Re: Initial Submission Review: 60th Avenue at Box Elder – Infrastructure Site Plan
Application Number: DA-1478-14
Case Numbers: 2024-6039-00

3RD SUBMISSION REVIEW

BOX ELDER INFRASTRUCTURE SITE PLAN

THREE LANE COLLECTOR
TYPICAL SECTION (60TH AVENUE & 66TH/68TH AVENUE COLLECTION)
N.T.S.

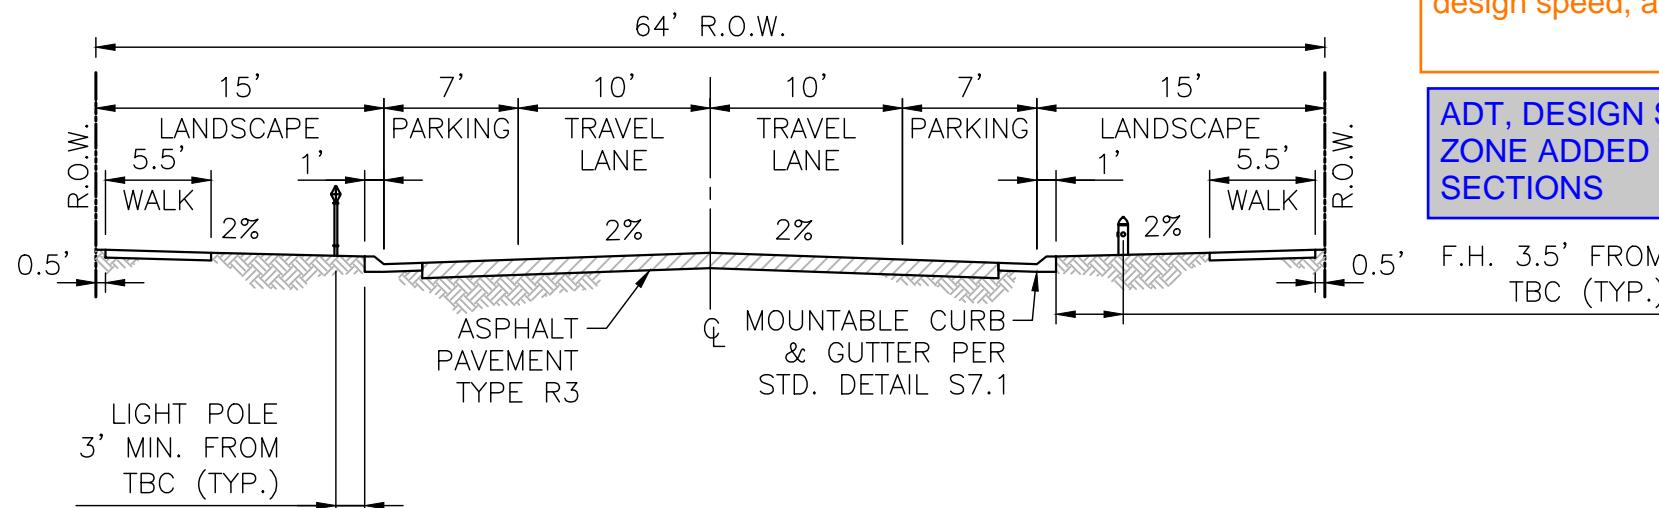
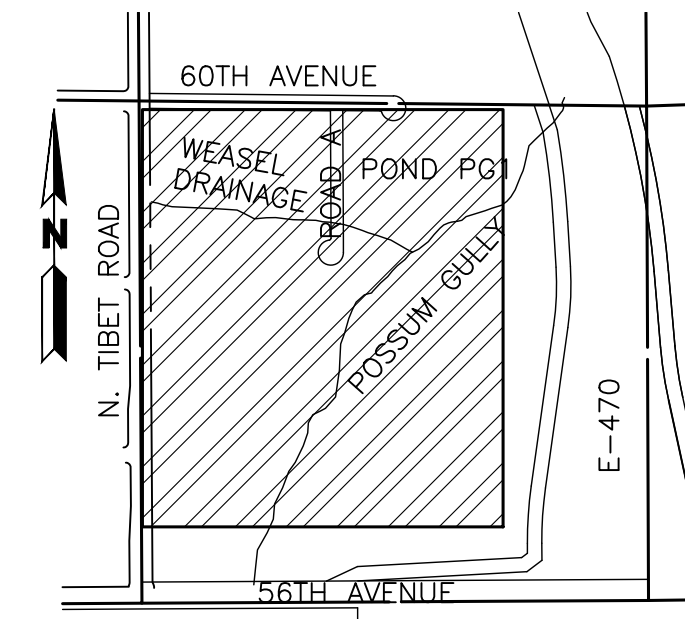
5A. Sheet 2: On typical sections will need ADT, design speed, and clear zone.

On typical sections will need ADT, design speed, and clear zone.

Response: *ADT, design speed, and clear zone added on typical sections*

ADT, DESIGN SPEED, AND CLAR ZONE ADDED TO TYPICAL SECTIONS

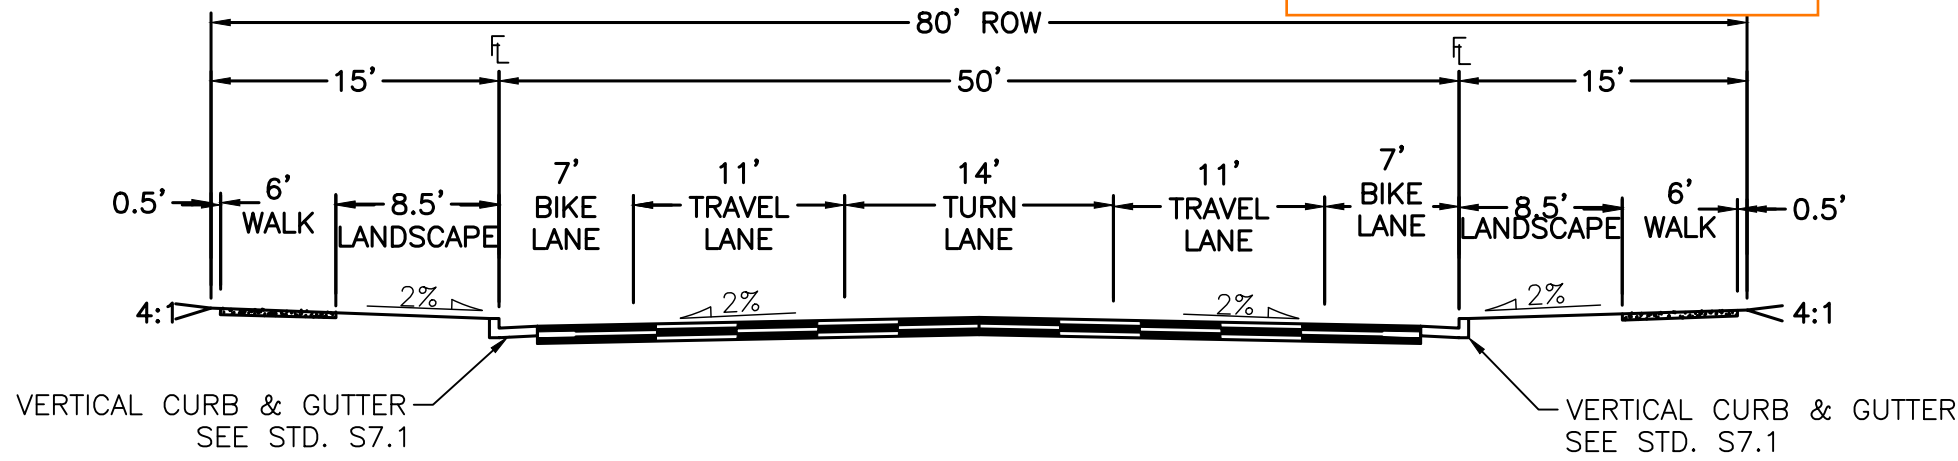
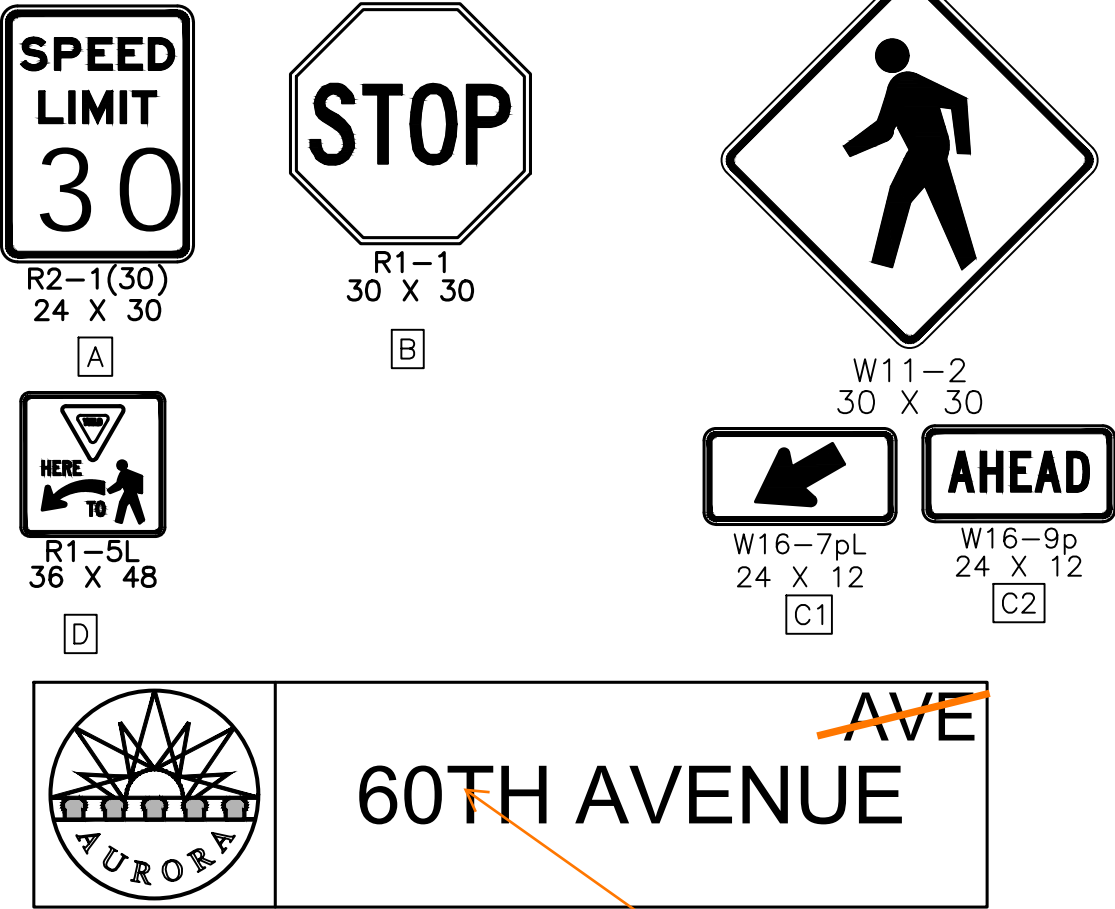
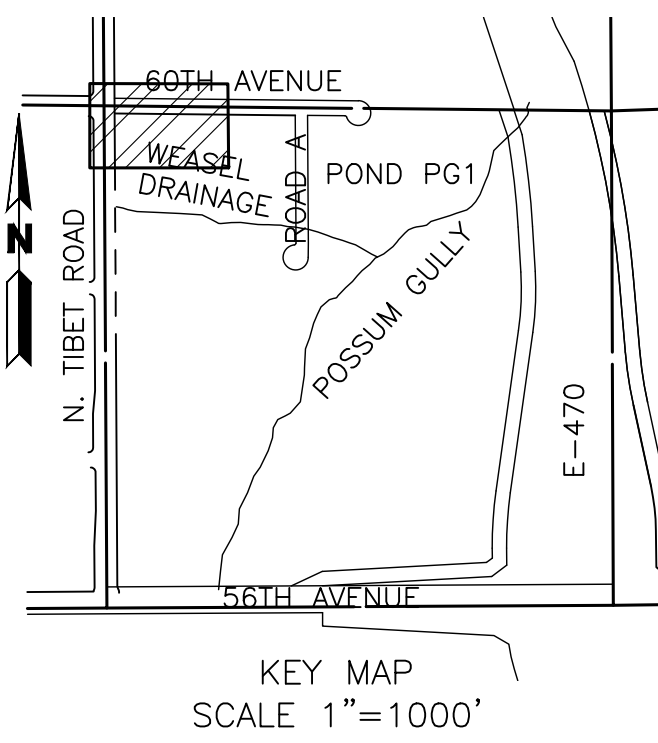
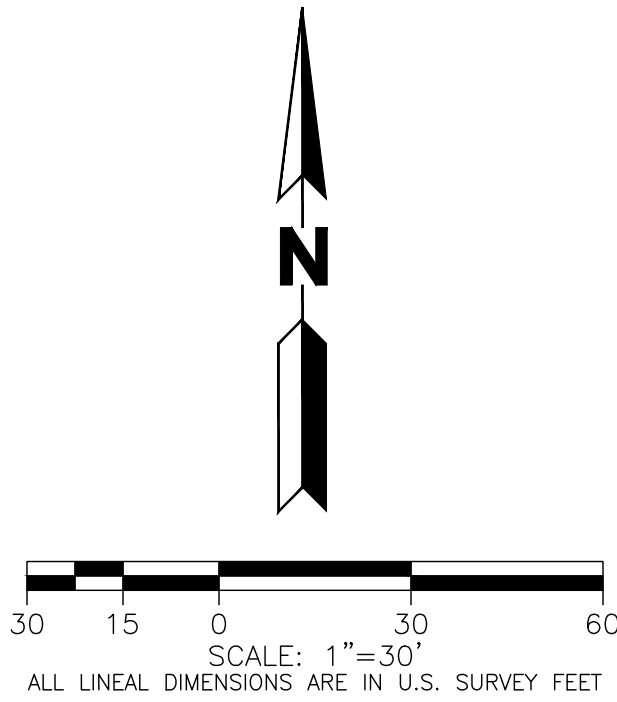
5D. Sheet 3: On typical sections will need ADT, design speed, and clear zone.

On typical sections will need ADT, design speed, and clear zone.

Response: *ADT, design speed, and clear zone added on typical sections.*

ADT, DESIGN SPEED, AND CLAR ZONE ADDED TO TYPICAL SECTIONS

SITE PLAN 60TH AVENUE

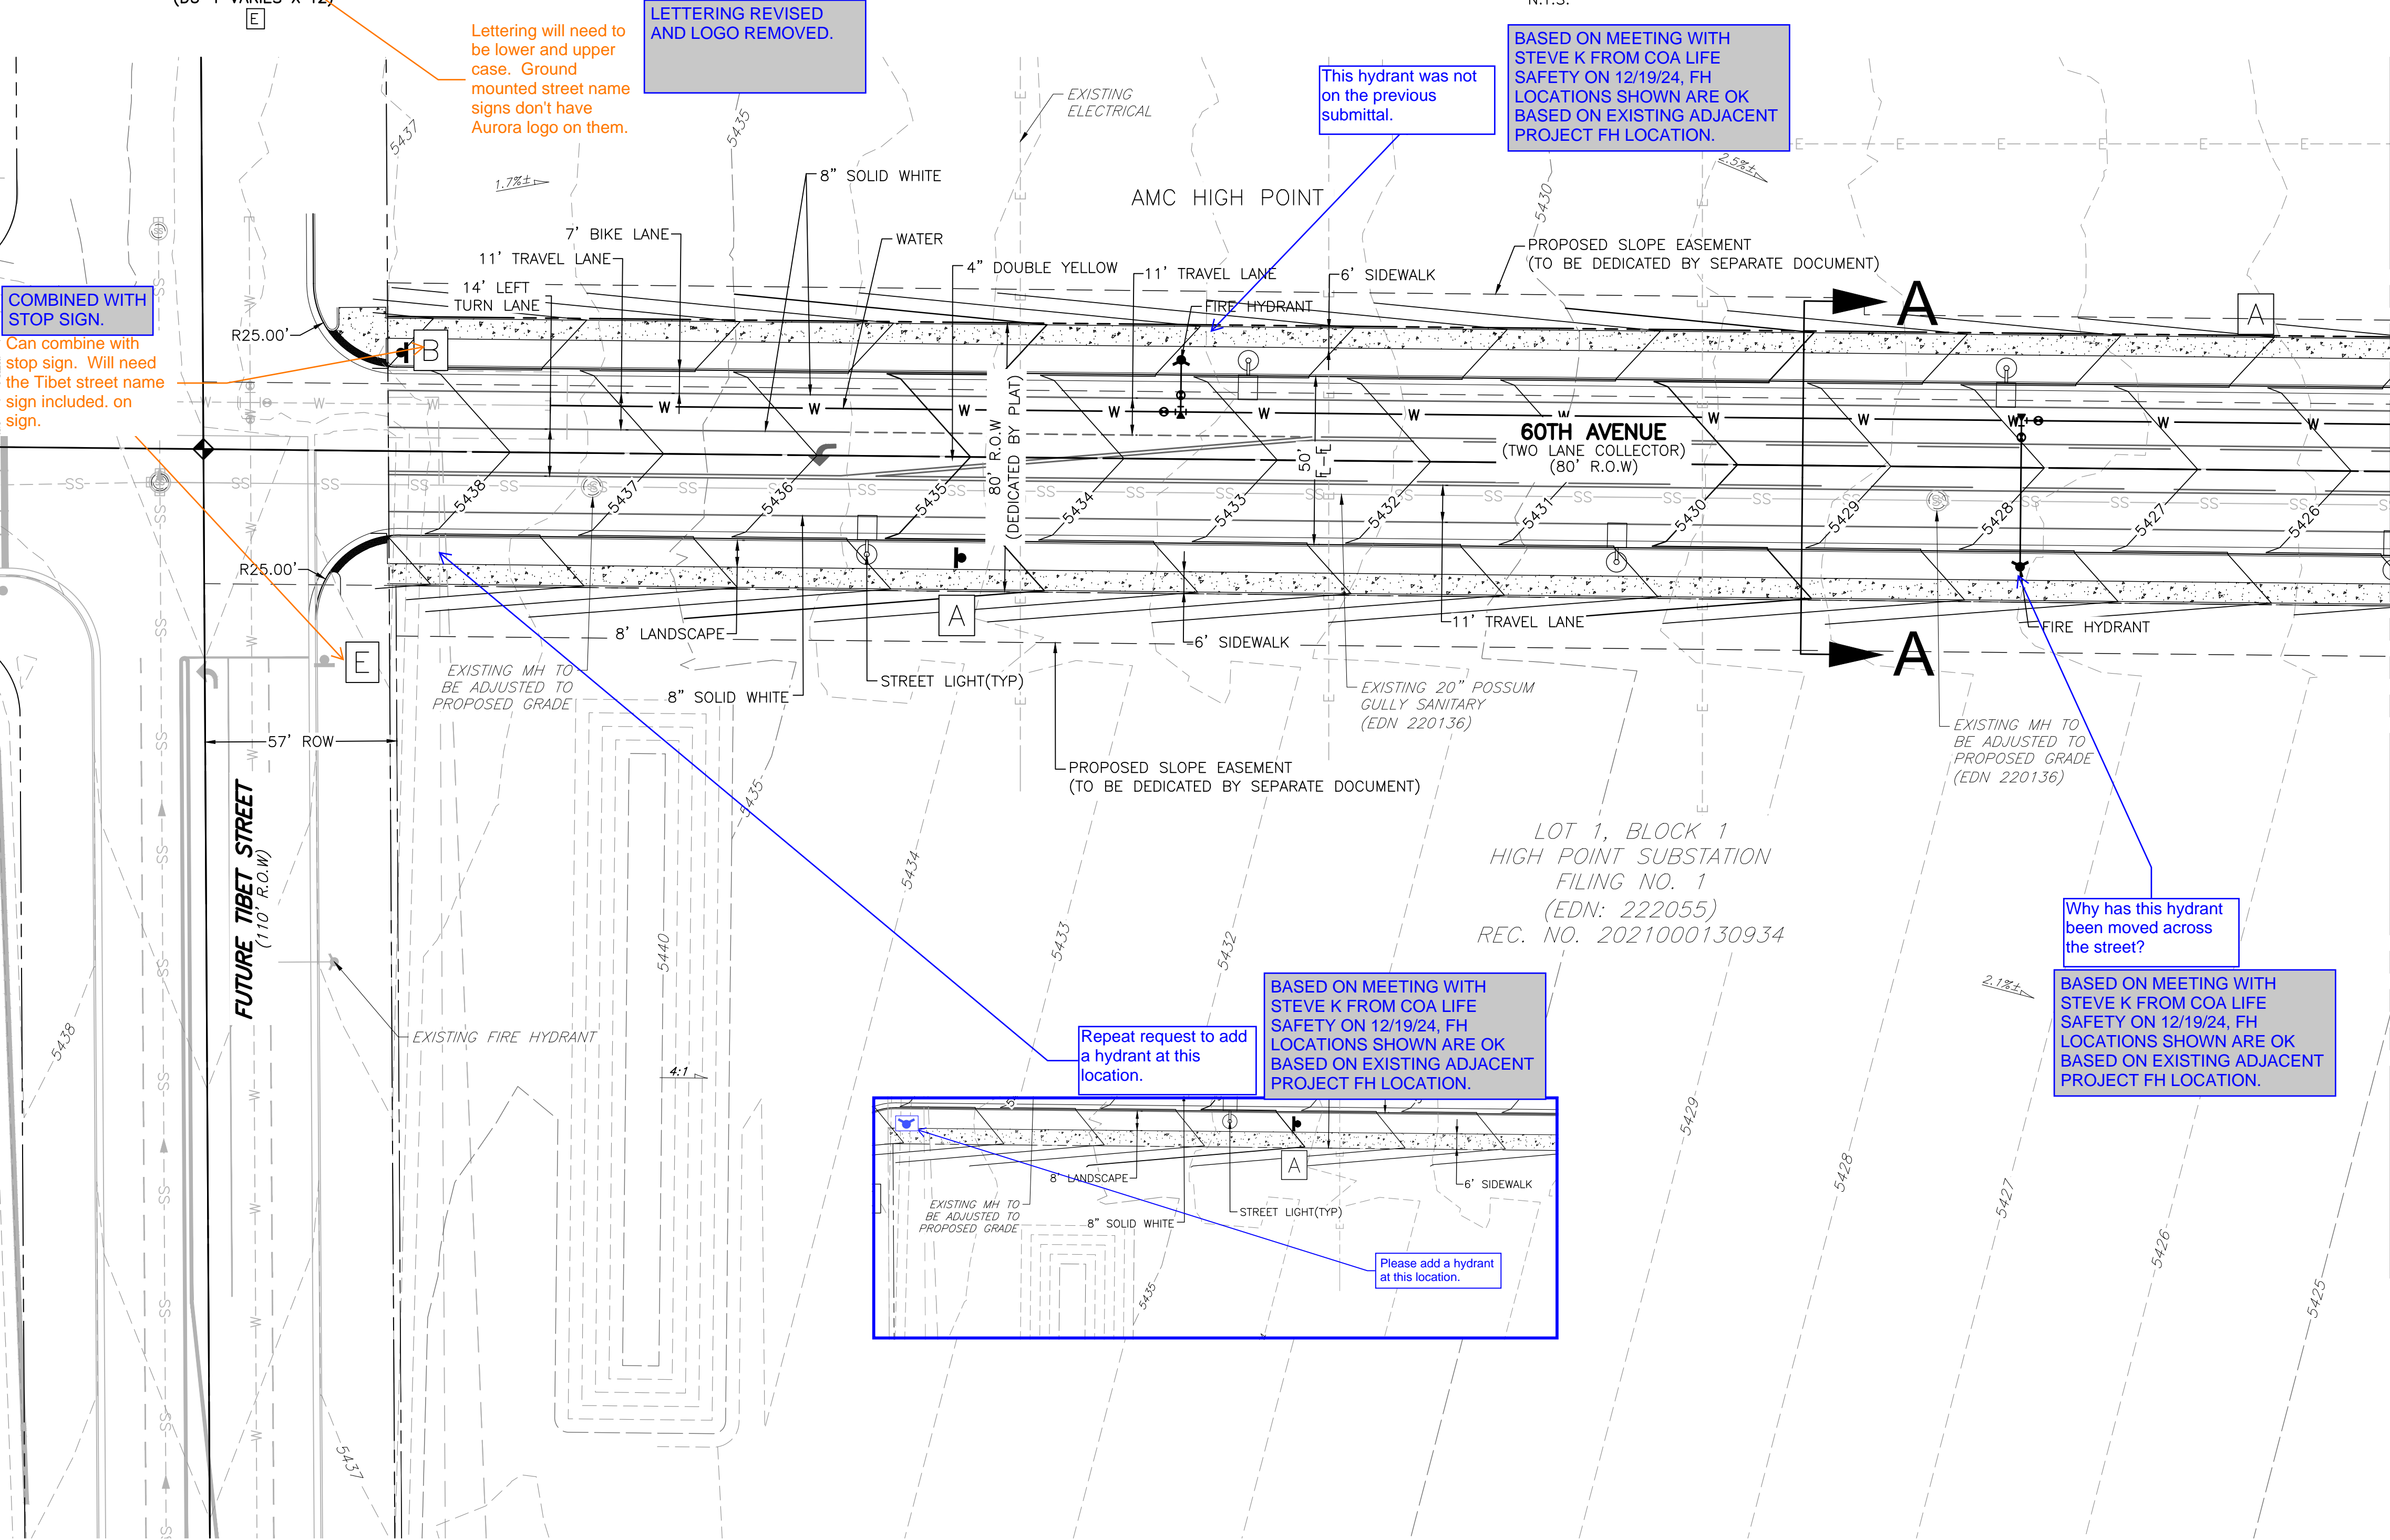
5B. Sheet 3: Can combine with the stop sign. Will need the Tibet Street name sign included. on sign.

5C. Sheet 3: Lettering will need to be lower and upper case. Ground-mounted Street name signs do not have the Aurora logo on them. **Response:** *Lettering has been revised and Aurora logo removed.*

6A. Sheet 3: Repeat request to add a hydrant at this location.

6B. Sheet 3: This hydrant was not on the previous submittal.

6C. Sheet 3: Why has this hydrant been moved across the street?

Response: *Street and stop sign combined.*

Response: *Based on meeting with Steve K. from COA Life Safety on 12/19/24, FH locations shown are ok based on existing adjacent project FH location.*

Response: *Based on meeting with Steve K. from COA Life Safety on 12/19/24, FH locations shown are ok based on existing adjacent project FH location*

Response: *Based on meeting with Steve K. from COA Life Safety on 12/19/24, FH locations shown are ok based on existing adjacent project FH location*
